**Re: Sunoco Pipeline L.P. – Pennsylvania Pipeline Project (Mariner East II)
E&S Permit Nos.: ESG0300015002; ESG0500015001; ESG0100015001
WO&E Permit Nos.: E02-1718; E06-701; E07-459; E11-352; E15-862; E21-449; E22-619; E23-524; E31-234; E32-508; E34-136; E36-945; E38-194; E50-258; E63-674; E65-973; E67-920
Project-wide Request to Allow Contractors to Replace Conventional Auger Bore with a Cradle Bore**

PENNSYLVANIA PIPELINE PROJECT

TYPICAL CRADLE BORE DETAIL

TYPICAL CRADLE BORE CROSSING LAYOUT
NOT TO SCALE

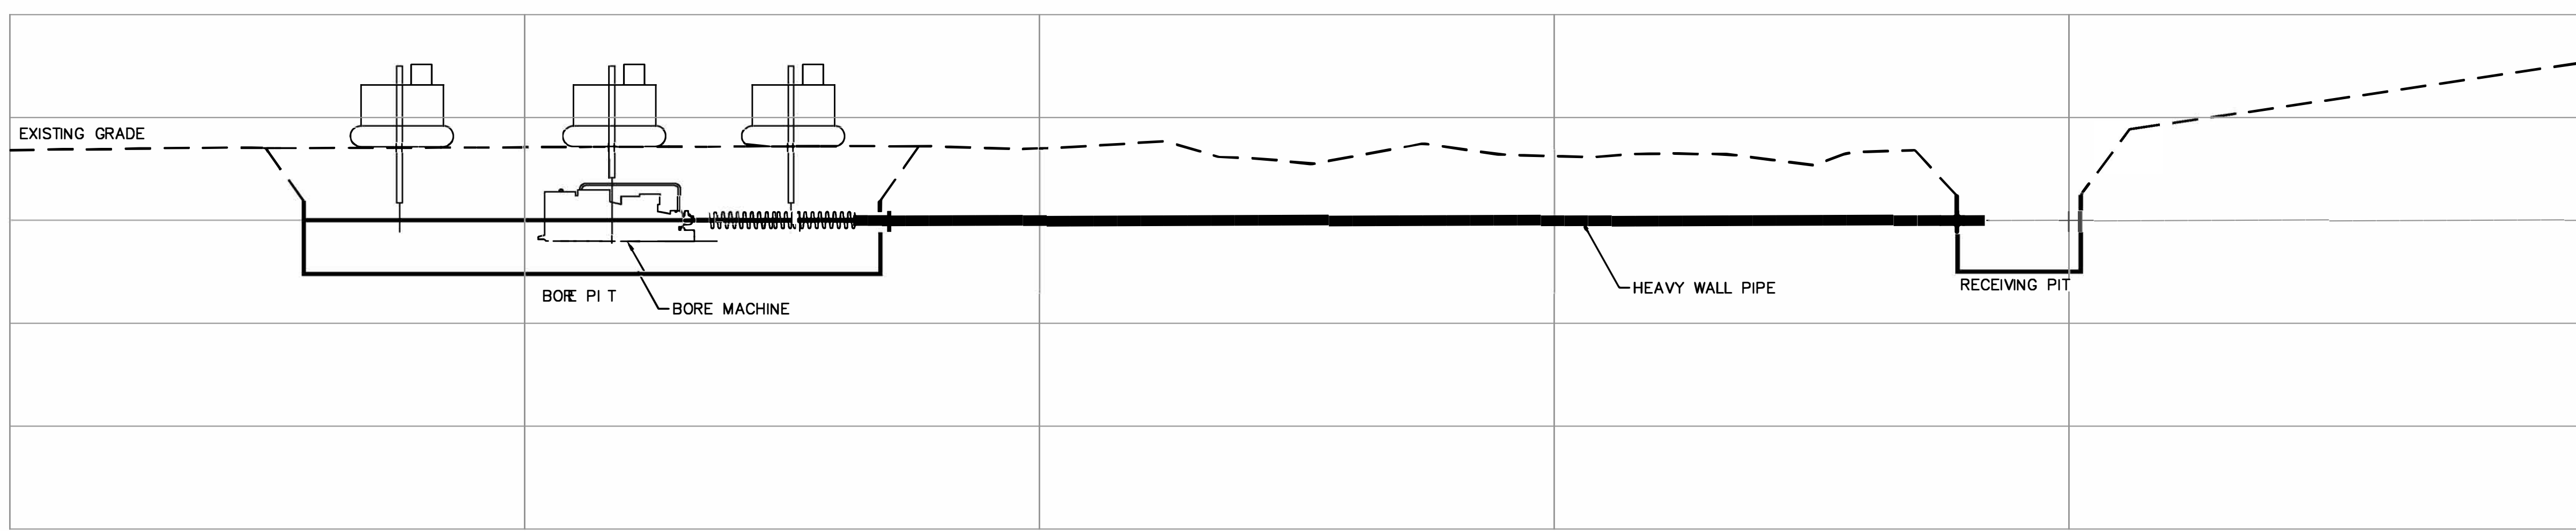
If approved by the Department, this modification would allow the contractor, at their discretion, to change the method of installation at authorized conventional auger bore sites to a cradle bore without further approval by the Department. A cradle bore is a minor variation of the conventional auger, and is different in that the boring unit is suspended within a trench using side booms and track hoes and is operated without the need to build a pit for construction workers. The cradle bore, also similar to the conventional auger bore, will be dry and will not use water, mud, or air to assist the auger. The entry and exits and profiles would remain the same as a conventional auger bore, and in cases where waters of the Commonwealth are crossed, the method change would not result in any increase to previously authorize temporary or permanent Chapter 105 impacts to waters of the Commonwealth. I have attached a typical detail for the cradle bore that will be used along with approved erosion and sediment control plans whenever this auger bore variation is planned.
